HARTZELL PROPELLER INC.

ALERT SERVICE BULLETIN

HC-ASB-61-338

Propeller - Replacement of B-119-2 Diaphragm

**B-119-2 Redesigned Diaphragm
Figure 1**

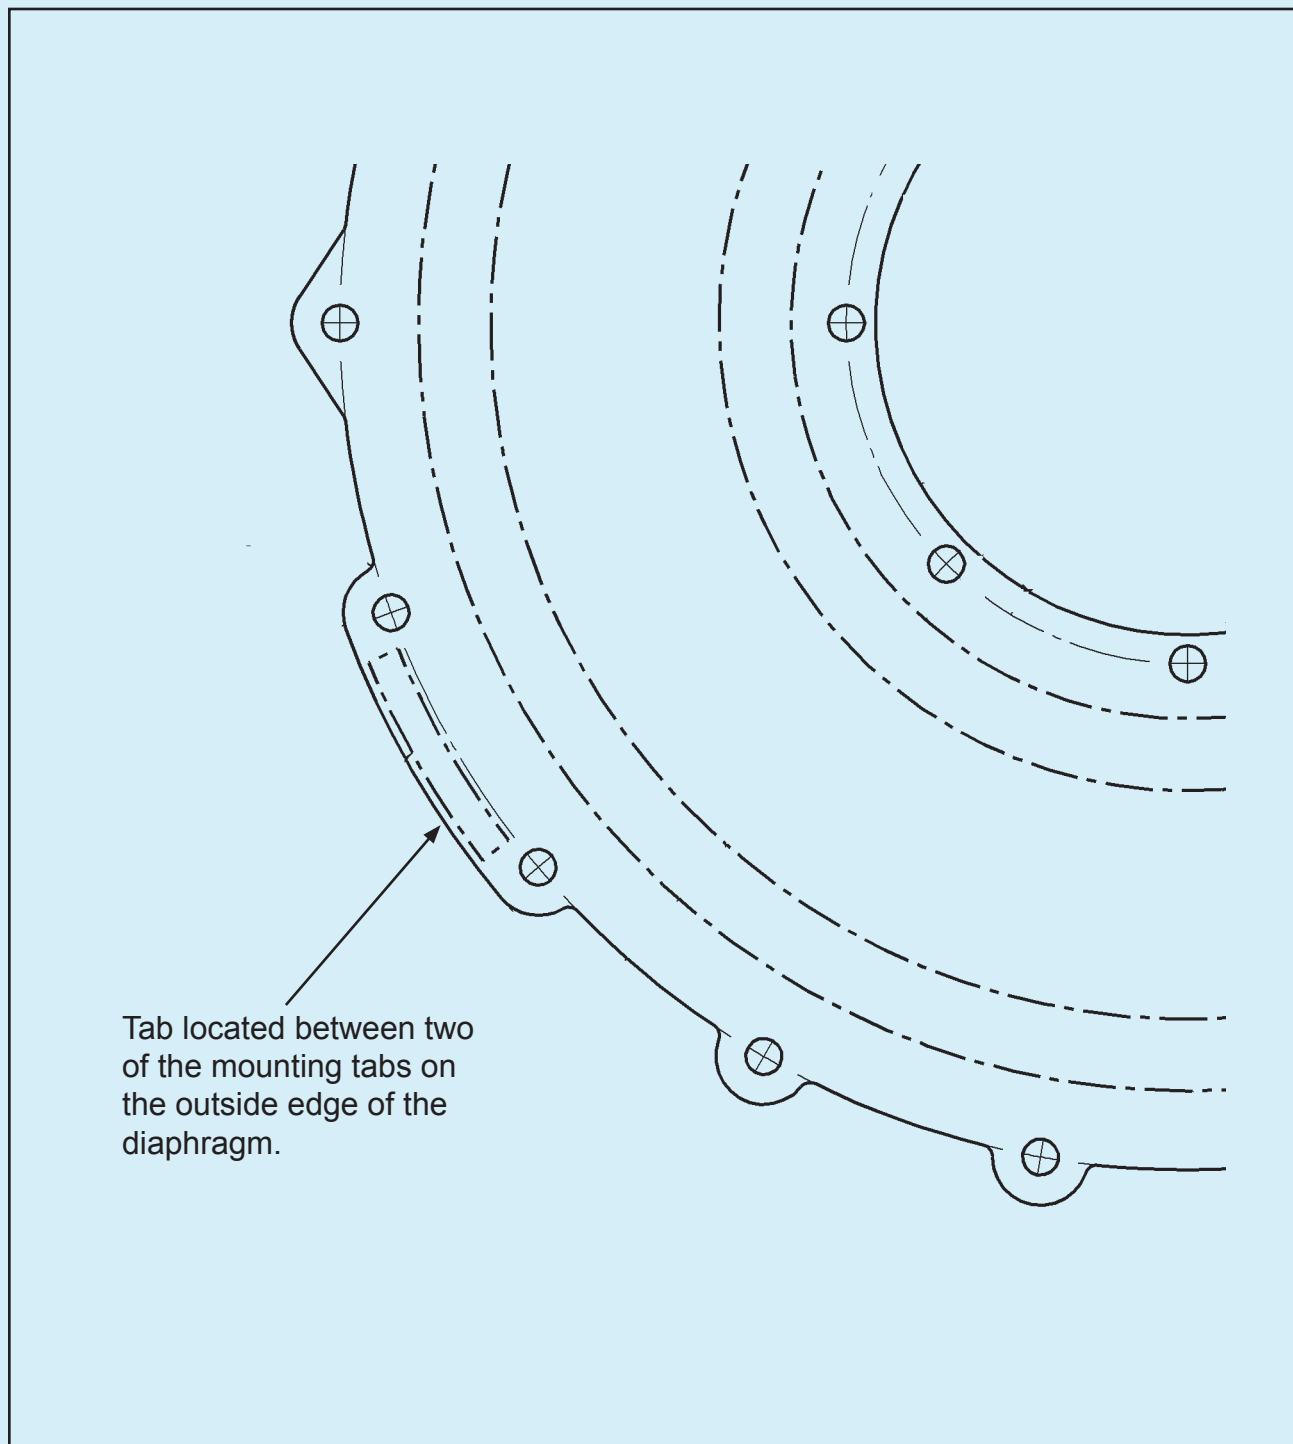
- (1) This document provides Instructions for Continued Airworthiness (ICA).
- (2) The original issue of this Alert Service Bulletin required an initial and repetitive inspection of the B-119-2 diaphragm.
- (3) The original design B-119-2 diaphragm did not include a tab for identification.
- (4) Revision 1 to this Alert Service Bulletin required replacement of the original design B-119-2 diaphragm.
 - (a) The redesigned B-119-2 diaphragm was designed with a tab located between two of the mounting tabs on the outside edge of the diaphragm. Refer to Figure 1.

NOTE: This tab will be marked with a batch/lot number.
